**Wisconsin  
Electric**  
POWER COMPANY

VPNPD-89-522  
NRC-89-121

October 3, 1989

DOCKETS 50-266 AND 50-301  
MODIFICATION TO TECHNICAL SPECIFICATION CHANGE REQUEST 126  
REVISION TO HEATUP AND COOLDOWN LIMIT CURVES  
POINT BEACH NUCLEAR PLANT, UNITS 1 AND 2

Figure 15.3.1-1/PBNP Unit Nos. 1 & 2  
Heatup Limitations Applicable to  
18.1 Effective Full Power Years  
(Approximately January 1995)

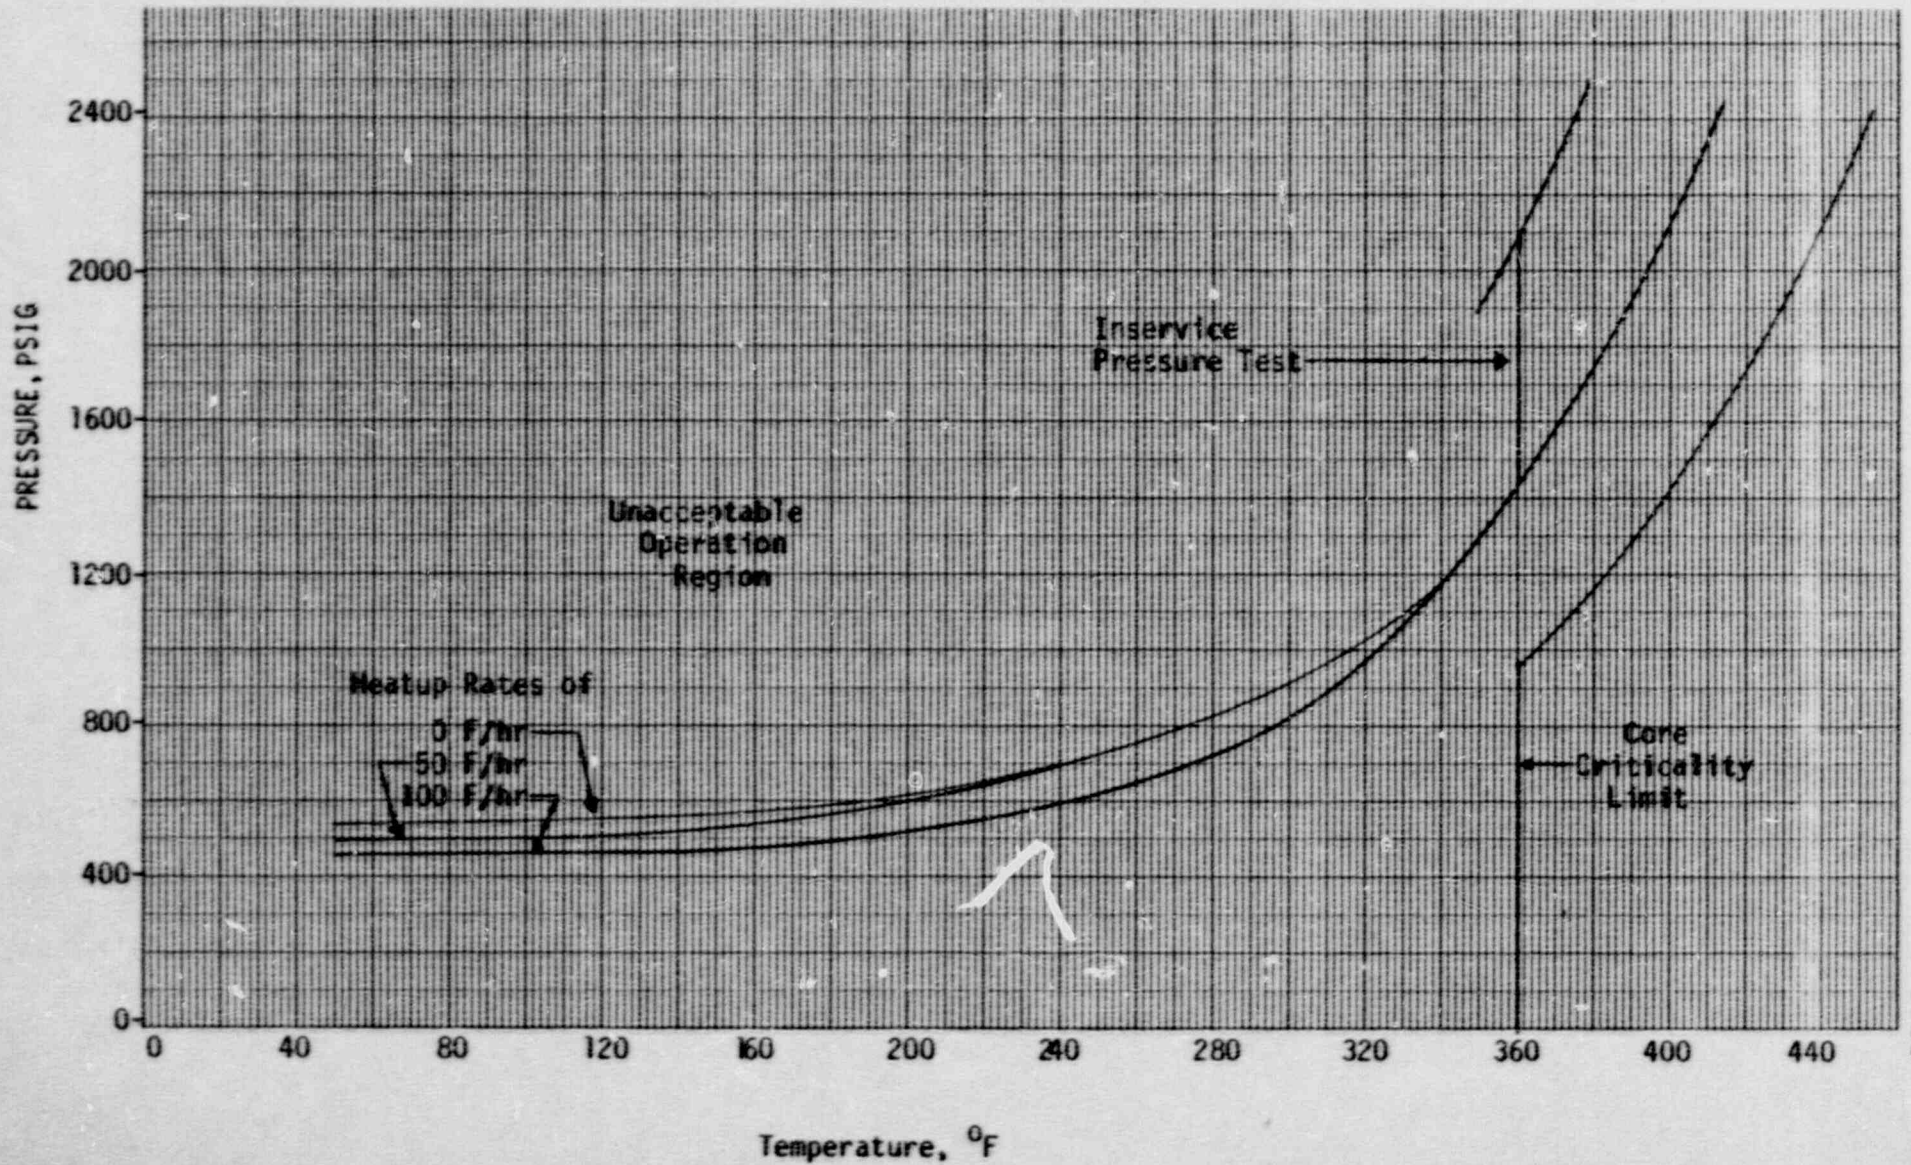
On August 31, 1989, Mr. Warren Swenson (NRC Project Manager) informed us that several apparent discrepancies existed between our proposed heatup limit curve and the NRC calculated curve. Specifically, our curve for the 100°F/Hr heatup was less limiting at higher temperatures. Upon further research and after review of data provided by Westinghouse Electric Corporation in a September 12, 1989 letter, it appears that the original T-RT<sub>NDT</sub> data for the 100°F/Hr heatup limit curve provided in Table 6-3 of WCAP-8738, contains several erroneous data points at higher temperatures. These errors were obscured in past submittals because margins were previously included for instrument uncertainties. Margins for instrument uncertainties were not included in TSCR #126, thus the discrepancies in the WCAP-8738 data became noticeable.

The new Westinghouse 100°F/Hr heatup data provided in their September 12, 1989 letter are more conservative at higher temperatures while the WCAP-8738 Table 6-3 data are more conservative at lower temperatures. We have therefore calculated a new T-RT<sub>NDT</sub> versus pressure data set using a conservative composite of the most limiting data from the 100°F/Hr heatup table found in WCAP-8738 and the data from the September 12, 1989 letter. The new heatup limit curve is again calculated using the methodologies of Regulatory Guide 1.99, Revision 2 and the calculational procedure of WCAP-8738 as described in our August 3, 1989 letter.

Accordingly, we have attached a revised Figure 15.3.1-1, "PBNP Unit Nos. 1 & 2 Heatup Limitations Applicable to 18.1 Effective Full Power Years (Approximately January 1995)." This replaces the Figure 15.3.1-1 proposed in our August 3, 1989 submittal; the remainder of that submittal is not changed.

The proposed heatup curves were derived from a conservative composite of our most limiting T-RT<sub>NDT</sub> data using the methodology of WCAP-8738. This data was calculated using the most limiting fluence and weld data from either unit as input to the acceptable methodology of Regulatory Guide 1.99, Revision 2. The modification to the original change request discussed in this letter actually results in a heatup curve which is more conservative than the curve presented in our original application. Therefore, the consequences or probability of a previously evaluated accident will not be increased nor will a margin of safety be reduced.
